# Access Compliance Report Public Rights-of-Way (Curb Ramps)

Main Street: CECIL\_PASTURE\_RD Cross Street: CECIL\_PASTURE\_RD Location: S

ADA ID: RPRK211102124007 Ramp Type: Type 1 - Perpendicular Initial Pass/Fail: Pass Overall Compliance: No Severity Score: 5

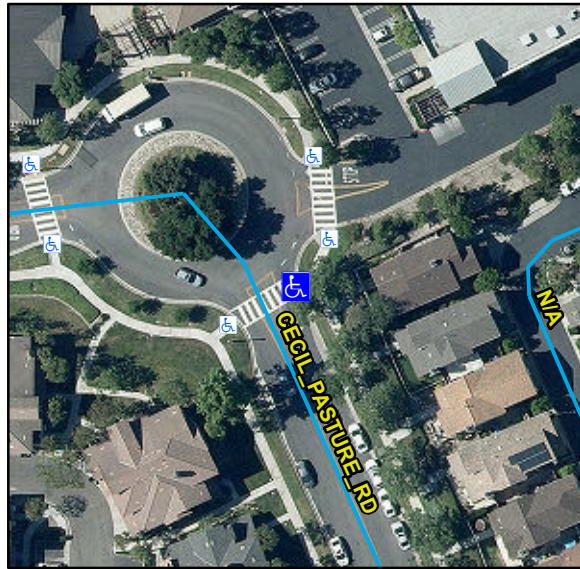
| Compliance | Description                           | Data | Compliance | Description                   | Data    |
|------------|---------------------------------------|------|------------|-------------------------------|---------|
| Yes        | Gutter Ponding                        | No   | No         | Curb Slope                    | 9.8     |
| No         | Gutter Run Slope (%)                  | 6.1  |            | Road Cross Slope (%)          | N/A     |

Remove & Replace Curb Slope. Remove & Replace Gutter.
